Comments on NorthWestern Energy's Final 2019 Electricity Supply Resource Procurement Plan

Prepared for Montana Public Service Commission

February 14, 2020

Synapse
Energy Economics, Inc.

Figure 2. Average hourly energy contribution on peak day with Beaver Creek

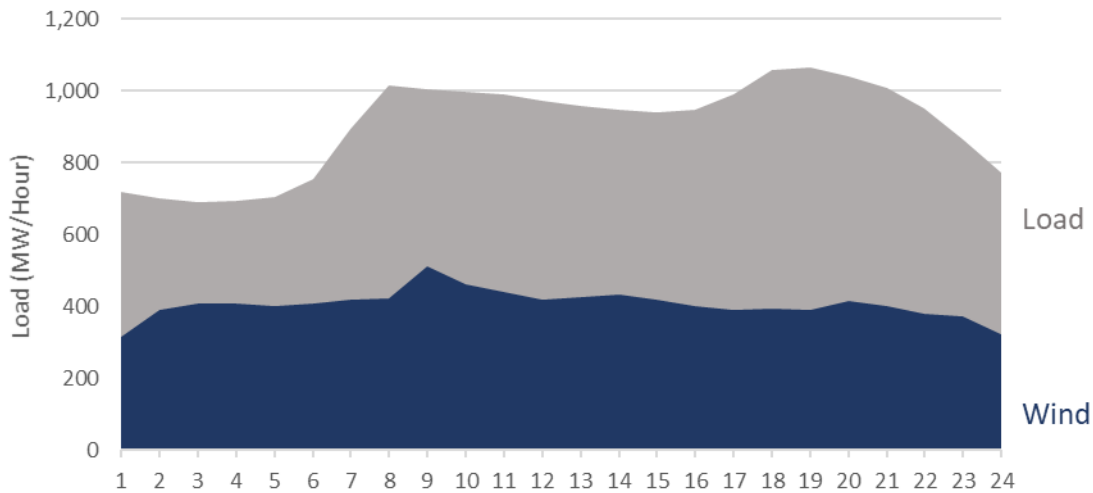
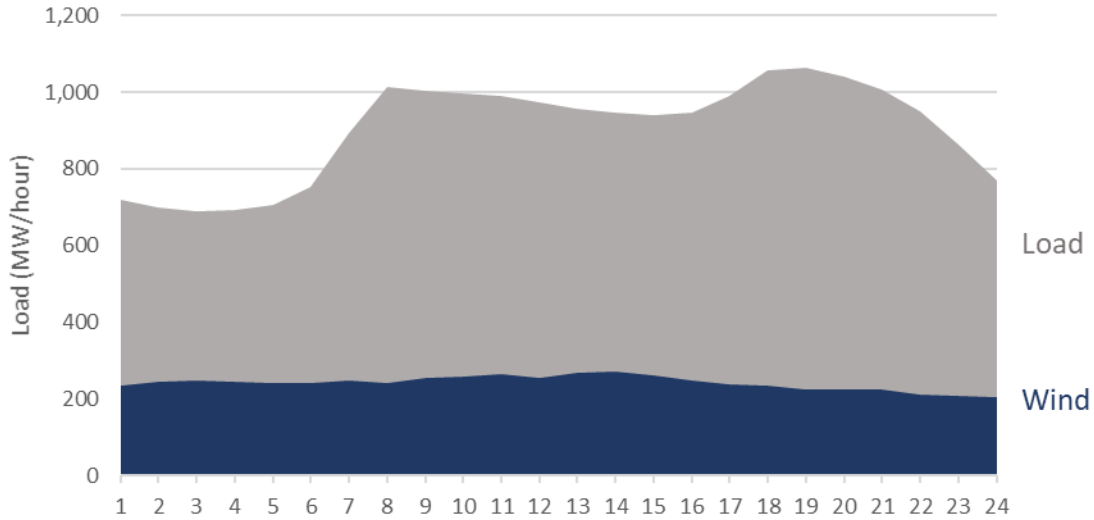
Contributions to daily energy requirements do not reflect the expected contribution of the wind or solar resource to capacity needs during the peak hours, but they do highlight the critical importance of the resource to meeting energy requirements over the course of a peak winter or summer day. The average peak hour (winter, 6 PM) contribution from wind from our computations was greater than 40% in all years, although we did not control for correlations between load level and wind level within the 100 simulations provided by Ascend in the PowerSimm model.

One of the projects included in the wind data we received was for the proposed 320 MW Beaver Creek wind-plus-storage project (four wind turbines at 80-MW each, plus 160 MWh of battery storage). These data included contributions from this project for the years 2020–2037. The contributions of this project were excluded from the analysis in Table 4 above, but we note that when the project is added back to the mix, the average contribution of wind projects increases noticeably. Figure 2 and Figure 3, below, represent the average simulated winter peak day in 2020 with and without the Beaver Creek resource, respectively.

Figure 4. NorthWestern’s new resource costs for renewables and batteries

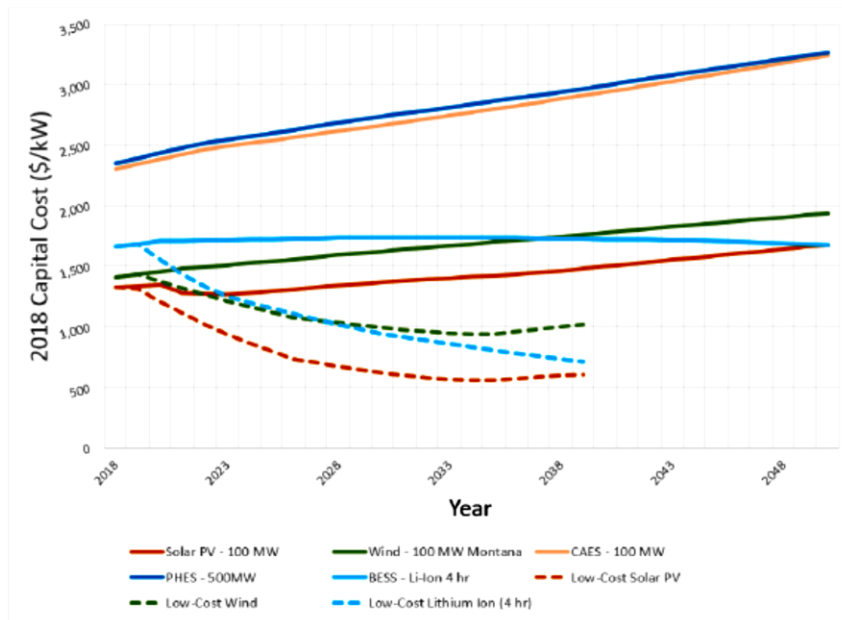
In Chapter 11 of its Final Plan, NorthWestern notes that it received comments from several parties stating that the unsubsidized costs of renewable resources are too high.⁹ Comments also noted that Ascend Analytics developed lower cost trajectories for wind, solar, and Li-ion batteries but did not use those costs in portfolio modeling.¹⁰ Those trajectories are shown in Figure 4, below.

NorthWestern’s response to these comments is that the original Base Case was re-run with the lower cost trajectories for these resources, and these lower cost futures had no effect on the resource selection. Therefore, NorthWestern chose not to include these resources, at these lower costs, as an option in future scenario modeling.¹¹ This is flawed, as described below.

At a minimum, it would have been useful for NorthWestern to model the portfolios that fix the additions of renewable and storage resources using the lower cost trajectories. The Li-ion Battery portfolio has a revenue requirement that is only \$15 million more than NorthWestern’s Base portfolio under reference capital costs. A lower capital cost for battery storage technologies would lower the revenue requirement associated with that particular portfolio, perhaps bringing the cost below that of the Base portfolio.

Figure 5. PowerSimm portfolio setup

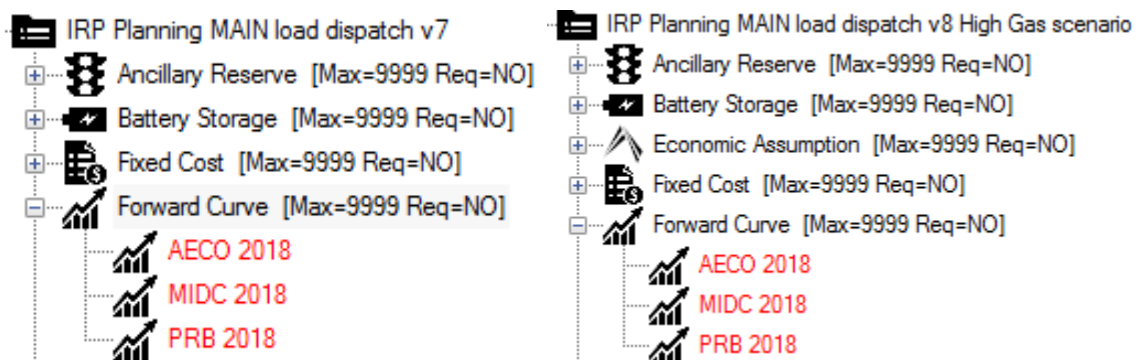
NorthWestern claims in the Final Plan that it modeled a High Natural Gas Prices Scenario, which contains all of the assumptions included in the Base portfolio but escalates gas prices at 150 percent of the Base case escalation. The Company also claims that, as in the Base portfolio, resources were added to the portfolio using constrained ARS analysis.¹³ However, upon looking at the setup of the PowerSimm model, Synapse noticed that there was no High Gas Price capacity expansion portfolio, meaning PowerSimm would be unable to run a constrained ARS analysis with this new sensitivity (see Figure 5, in which there is a “load dispatch” study for a High Gas scenario, but no “HDRCapital” study). Additionally, the load dispatch portfolio labeled as the “High Gas scenario” uses the same forward price curve (AECO 2018) for natural gas as the Base scenario, as opposed to using prices 150% higher than the Base scenario as stated in the Plan (see Figure 6). For these reasons, we believe that NorthWestern did not actually model a High Natural Gas Price scenario despite describing one in its plan.

Figure 8: Solar fixed O&M cost comparison

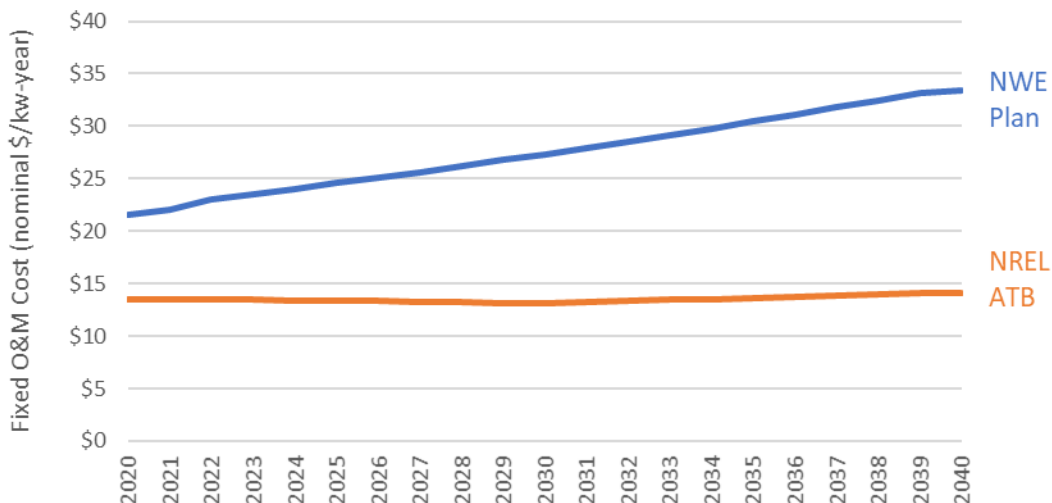
The solar resource fixed O&M assumptions in PowerSimm used in NorthWestern’s IRP modeling were unreasonably high, at \$21.60/kW-year for a new 100 MW solar installation.¹⁸ Lazard’s Levelized Cost of Energy study from 2019, which was referenced by several stakeholders in their comments on the Draft Plan, estimates that utility-scale solar PV Fixed O&M costs are between \$9–\$12 per kW-year.¹⁹ NREL’s 2019 ATB estimates 2019 Fixed O&M costs to be about \$13 per kW-year²⁰ with costs continuing to decline in real terms over time. This means that industry standards are about two-times lower than

what NorthWestern assumes in its plan. A comparison between NorthWestern’s assumption and the NREL 2019 ATB is shown in Figure 8.

This assumption is an important one because the PowerSimm model considers capital, fixed, and variable costs of new resources in its optimization. A high fixed cost is one more disadvantage unreasonably given to solar resources by NorthWestern, in addition to higher capital costs and a capacity credit of zero.
